WATERVUE

643-651 HUNTER STREET NEWCASTLE NSW 2300

DEVELOPMENT APPLICATION SHEET LIST		
DRAWING NO.	TITLE	REVISION
DA000	PLAN - LOCATION & DRAWING SCHEDULE	F
DA002	SITE ANALYSIS	B
DA003	PREDICT LOCATION PLAN	C
DA005	SITE PLAN	B
DA006	SHADOW DIAGRAMS	B
DA007	SHADOW DIAGRAMS	B
DA008	SHADOW DIAGRAMS	A
DA009	SOLAR ACCESS DIAGRAM	B
DA010	VENTILATION DIAGRAMS	B
DA011	PLANNING - GFA	C
DA012	UNIT AREA FOR CARPARKING GEN.	B
DA101	GROUND FLOOR	E
DA102	PARKING LEVEL 1	D
DA103	PARKING LEVEL 2	C
DA104	PARKING LEVEL 3	C
DA105	PLAN - PODIUM	E
DA106	PLAN - TYPICAL LOWER	D
DA107	PLAN - TYPICAL UPPER	C
DA111	PLAN - PENTHOUSES	B
DA112	ROOF	B
DA200	STREETSCAPE ELEVATIONS	B
DA201	ELEVATIONS - NORTH AND EAST	F
DA202	ELEVATIONS - SOUTH AND WEST	C
DA301	SECTIONS	C
DA321	RAMP SECTION CARPARK	C
DA401	PERSPECTIVE	B
DA402	PERSPECTIVE	B
DA403	PERSPECTIVE	B
DA409	MATERIALS + FINISHES	B
DA801	PODIUM LEVEL PRIVACY SCREENS	A
DA802	SIGNAGE DESIGN INTENT	A

DRAWING No.	DA000
DRAWING TITLE	PLAN - LOCATION & DRAWING SCHEDULE
SCALE	1 : 1 @ A1
DATE	2023

DRAWING No. **DA202**
DRAWING TITLE **ELEVATIONS - SOUTH AND WEST**
SCALE **1 : 200 @ A1**
DATE **2022**

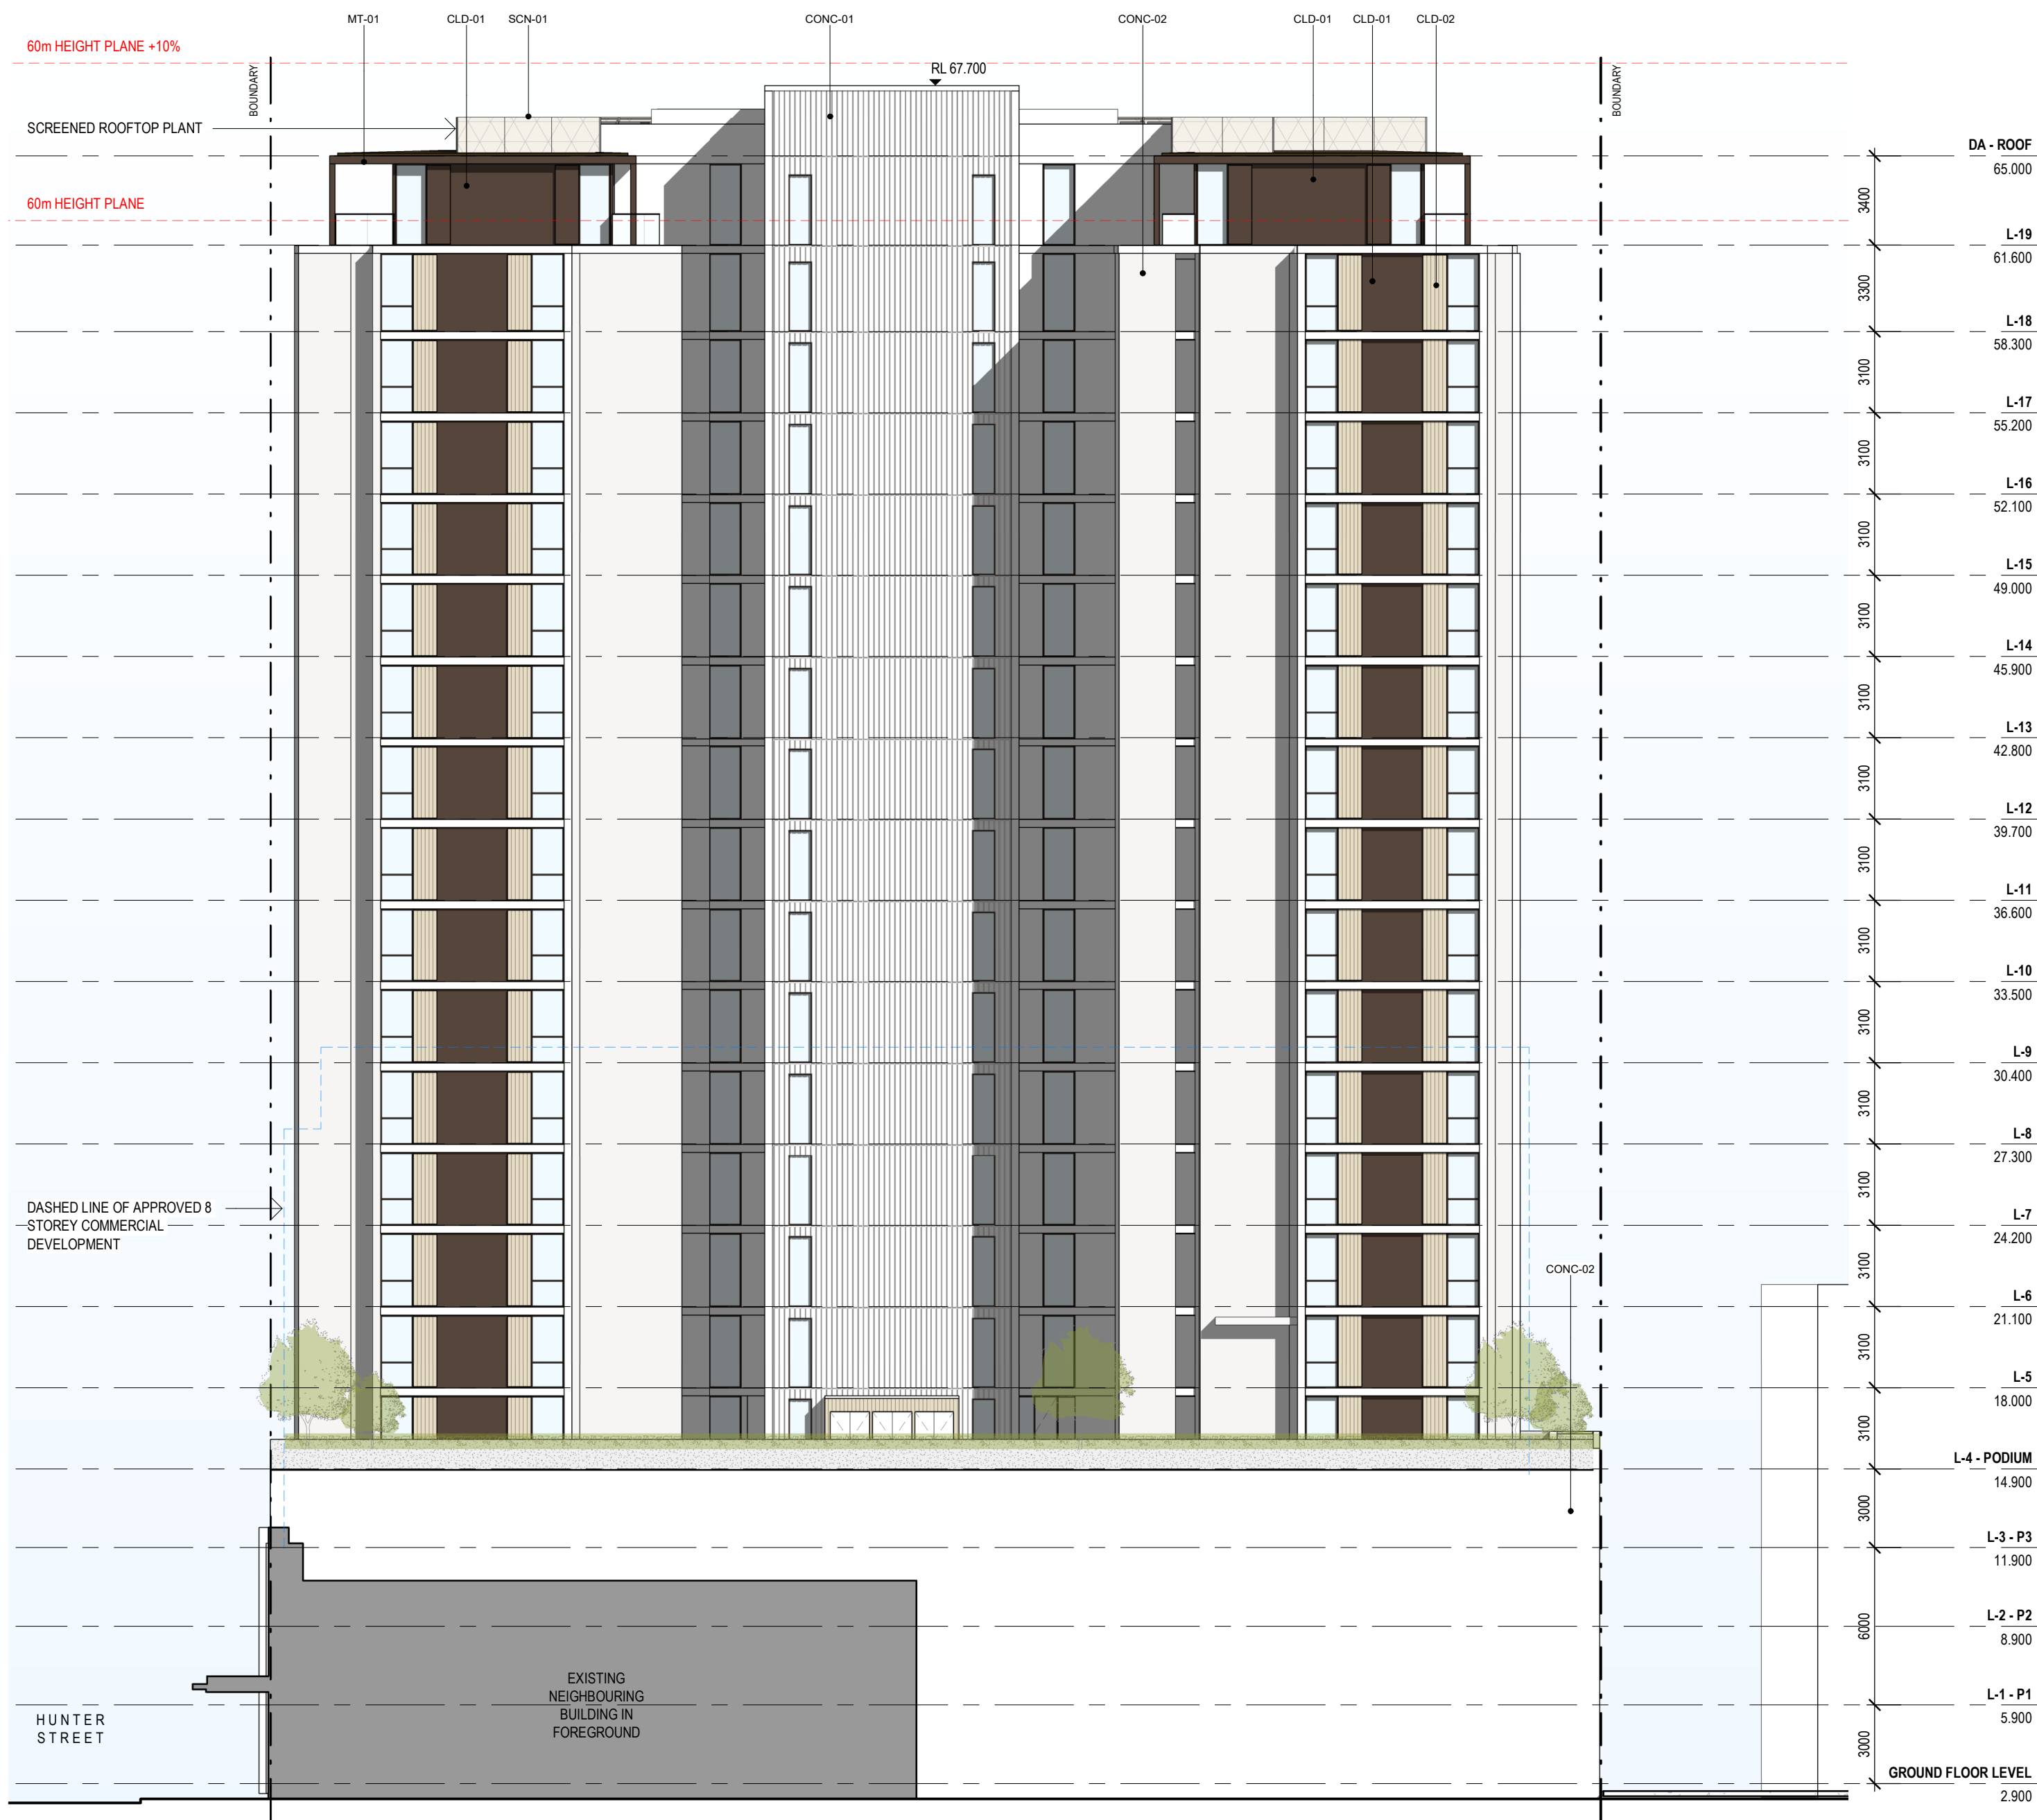
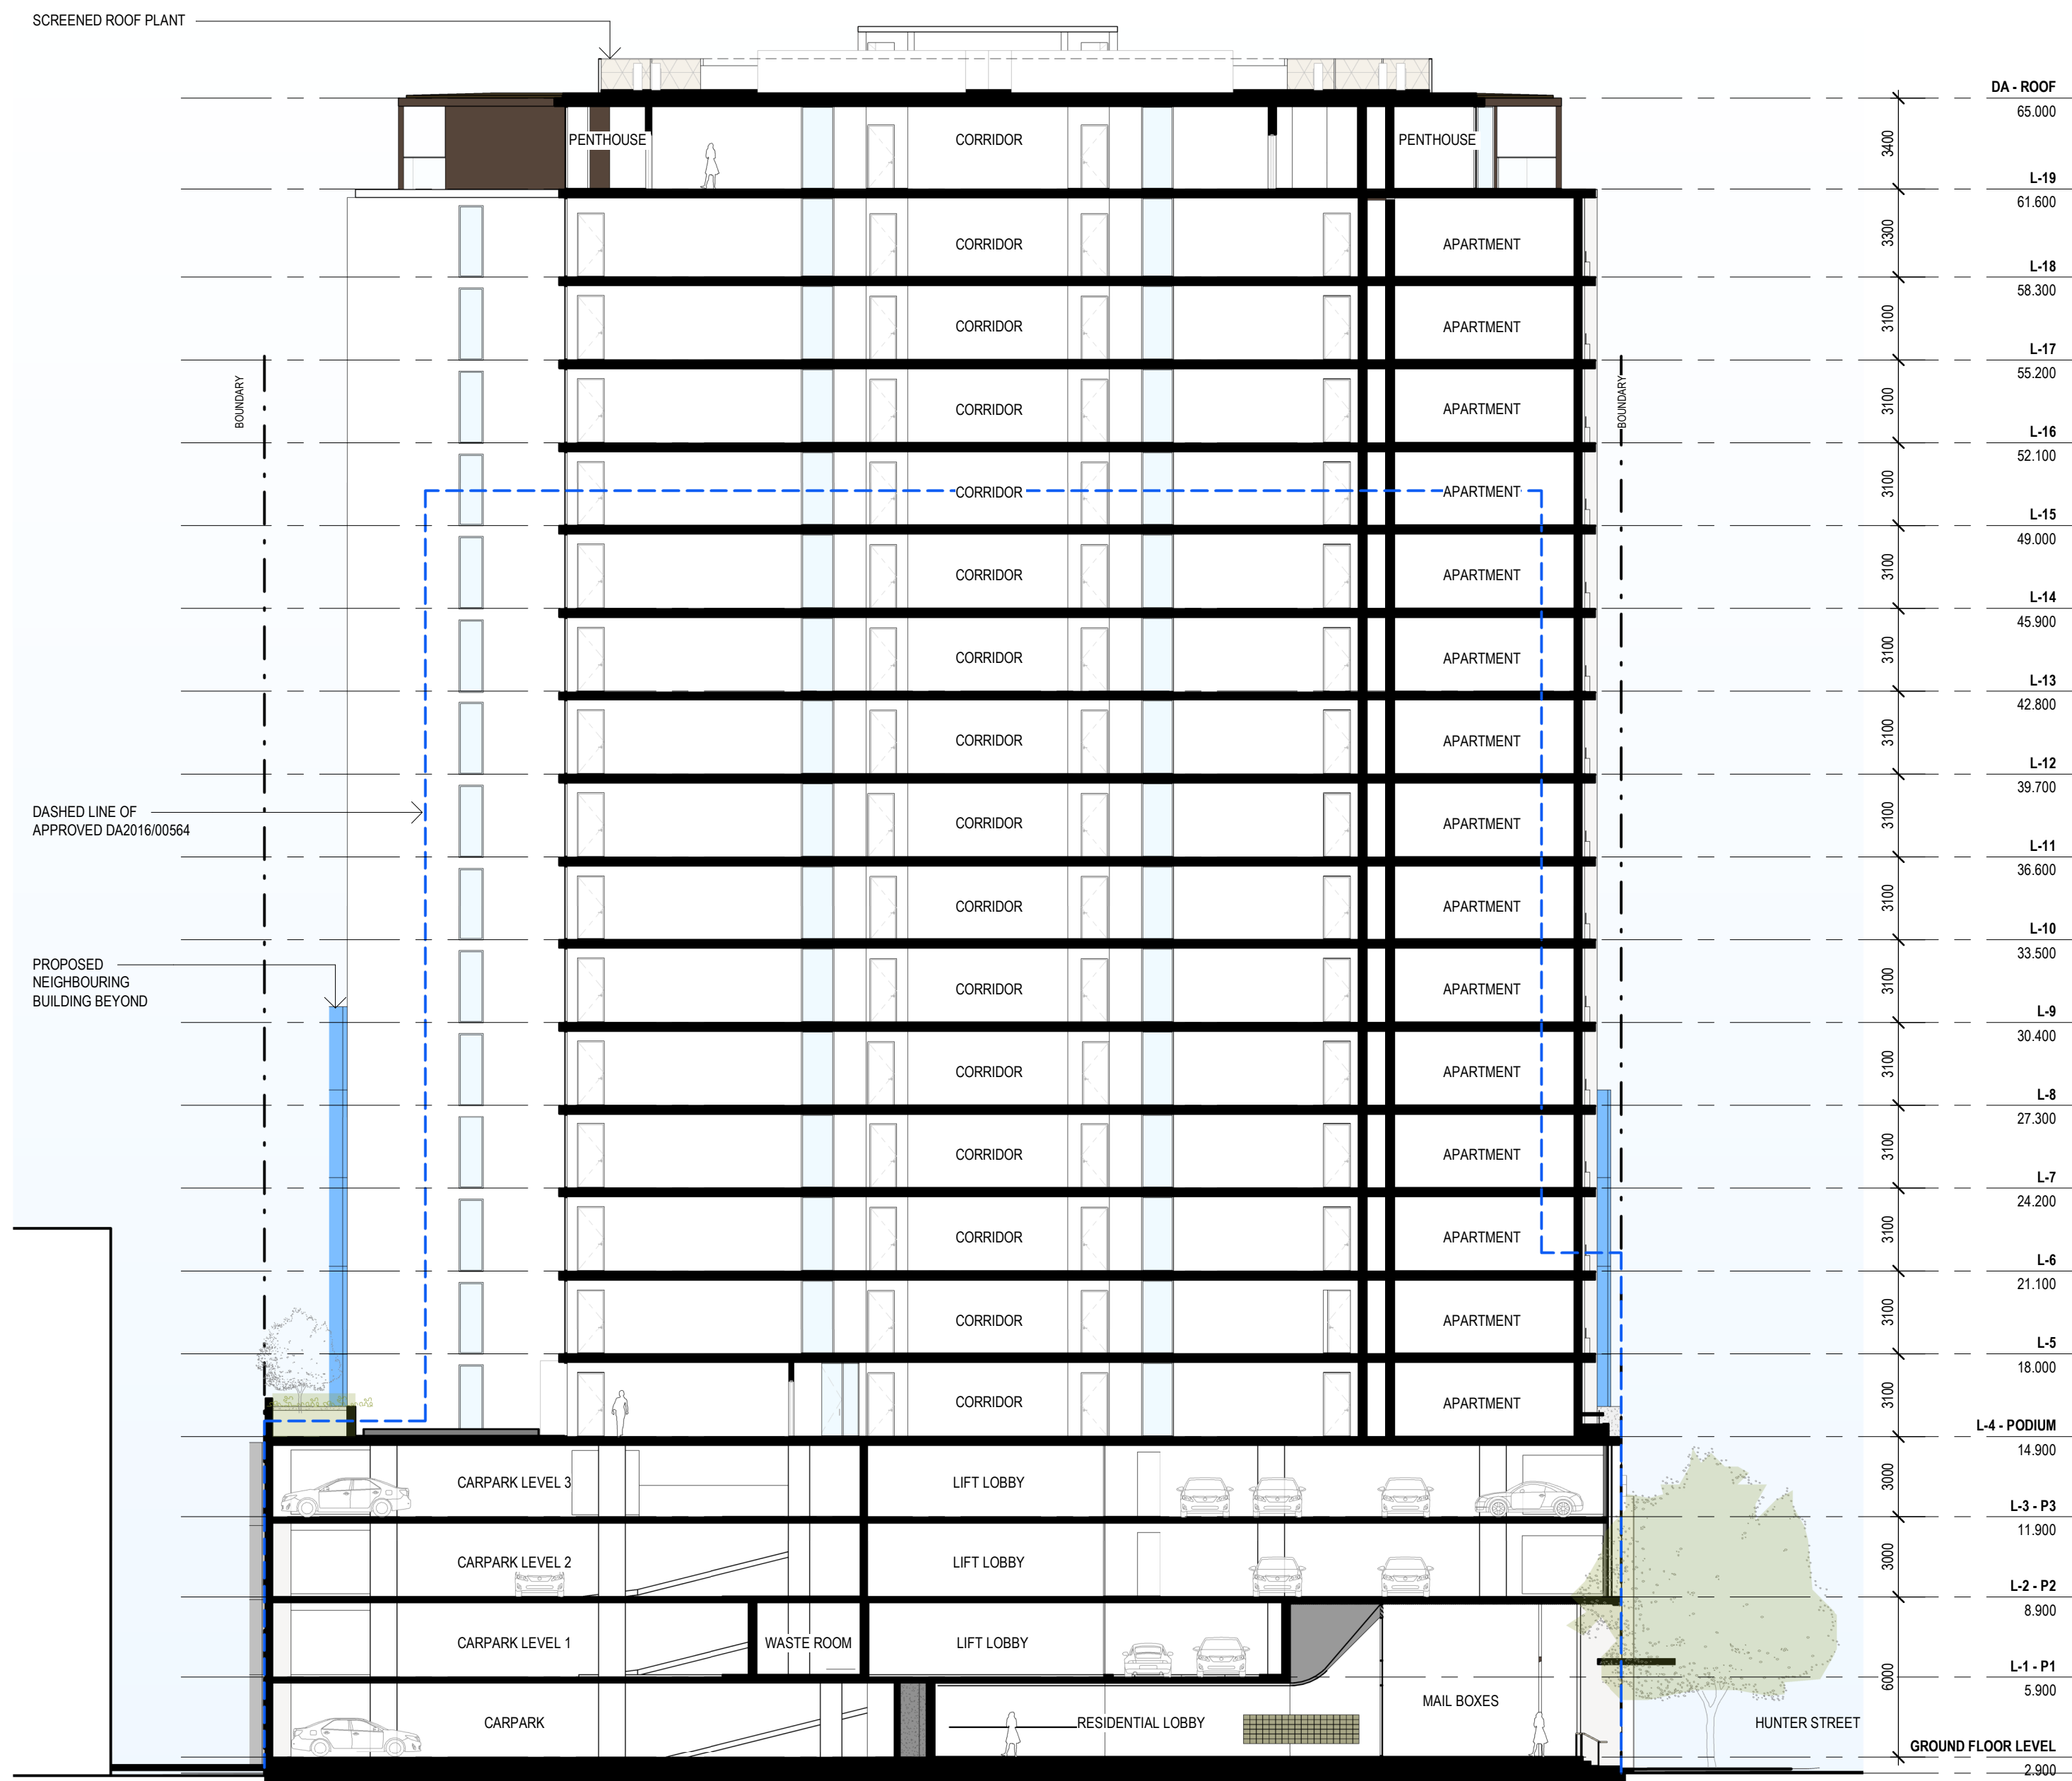
DA RFIS

- GROUND FLOOR CARPARKING LEVEL LOWERED BY 300MM
- DRIVEWAY GRADES UPDATED TO SUIT UPDATED PARKING LEVEL
- DOOR TO FIRE EGRESS CORRIDOR RELOCATED
- STEP ADDED TO FIRE EGRESS PATH TO SUIT UPDATED PARKING LEVEL
- STEPS AND PLATFORM ADDED TO MSB ROOM TO SUIT UPDATED PARKING LEVEL
- MAIL ROOM ADDED TO RESIDENTIAL LOBBY
- MAILBOXES RELOCATED INTO THE RESIDENTIAL LOBBY
- MOTORCYCLE SPACE DISTRIBUTION ACROSS L1, L2 AND L3 UPDATED (TOTAL REMAINS THE SAME)
- SECURE ENTRY ADDED AT BASE OF RESIDENTIAL CARPARK RAMP OF TO L1 RAMP LENGTH UPDATED TO SUIT UPDATED GROUND FLOOR PARKING LEVEL
- GARAGE ADDED TO L1 AND L2
- STORAGE CAGE ARRANGEMENT UPDATED
- LANDSCAPE COURTYARD ACCESS DOOR ADDED TO PODIUM LEVEL
- POOL PERGOLA SHOWN IN ELEVATION
